Preliminary Field Check For Drip Systems

COMAL COUNTY

RE: *2210 Grandview Forest*
Canon Lake Forest 1
Lot 221

OWNER: TALAVERA HOMES, LLC.				DRAWN BY: EJS III	
STREET ADDRESS: 2210 GRANDVIEW FOREST					
LEGAL DESC: CANYON LAKE FOREST			UNIT/SECTION/PHASE: 1	BLOCK:	LOT: 221
PREPARED BY: GREG W. JOHNSON, P.E. F#002585		SCALE: 1"=20'	DATE: 3/19/2025		REVISED:

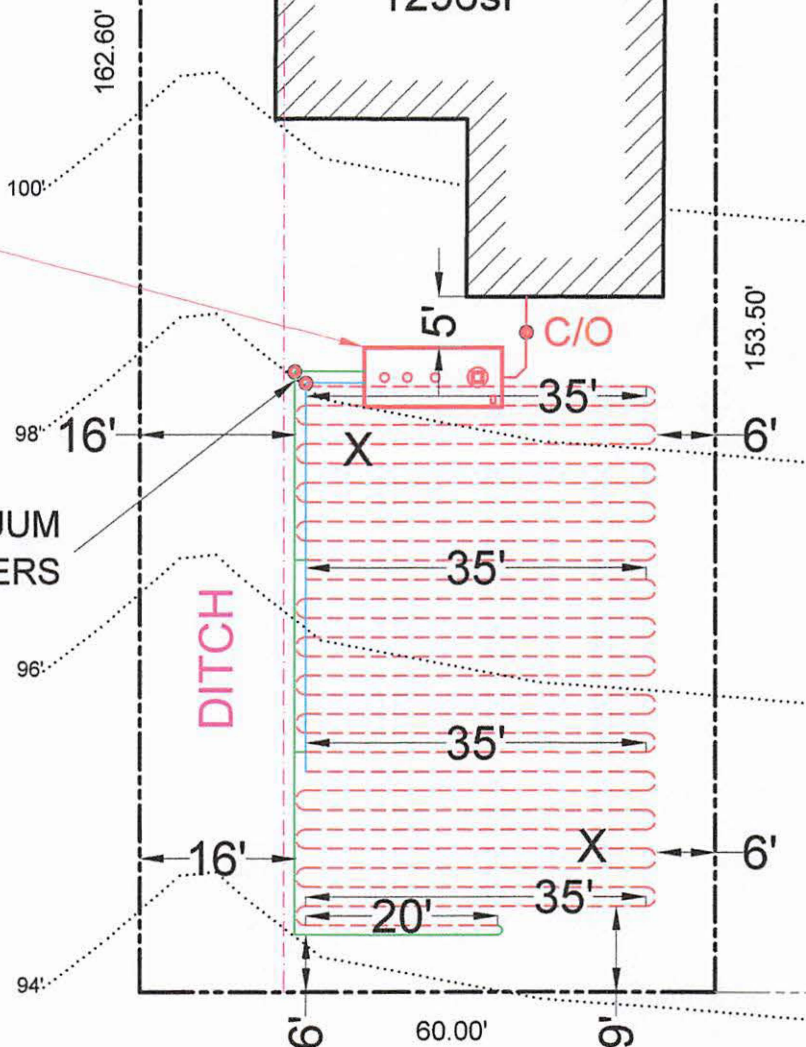
1. Application Page 2:
 - a. The permit number shown on the tank size(s) (gallons) is for a different property.
2. 285.91(10) Is the ditch an area where slopes where seeps may occur?
3. Revise accordingly and resubmit.
